P-1 CARRIER TELEPHONE SYSTEM
INSTALLATION AND WIRING OF NETWORKS

NOTES CONCERNING THIS ADDENDUM

This addendum is issued to replace one subparagraph and to delete references to grounding methods not standard in this area.

3.03(c) Where the low-pass network is located on a crossarm:

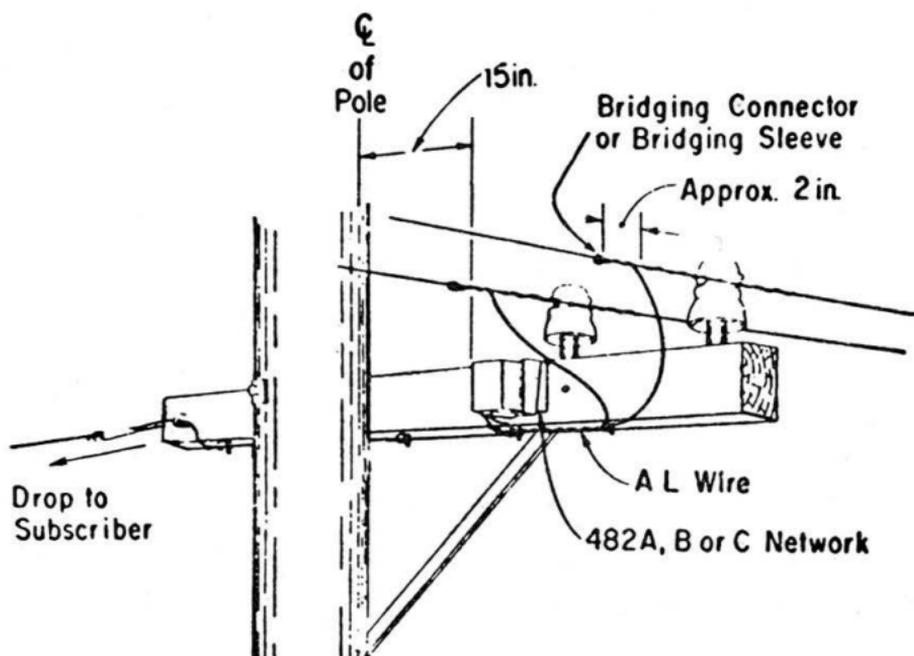
- Paragraph 2.03(g) - Delete "MGN Vertical Ground Wire"
- Paragraph 3.03(c) - Replaced
- Paragraph 4.02(c) - Delete "MGN Vertical Ground Wire"
- Paragraph 4.02(g) - Delete "MGN Vertical Ground Wire"

- 1 - Attach Network with two 1 in. No. 14 R.H. Galv. Wood Screws.
- 2 - See Par. 2.03 for wiring of network.
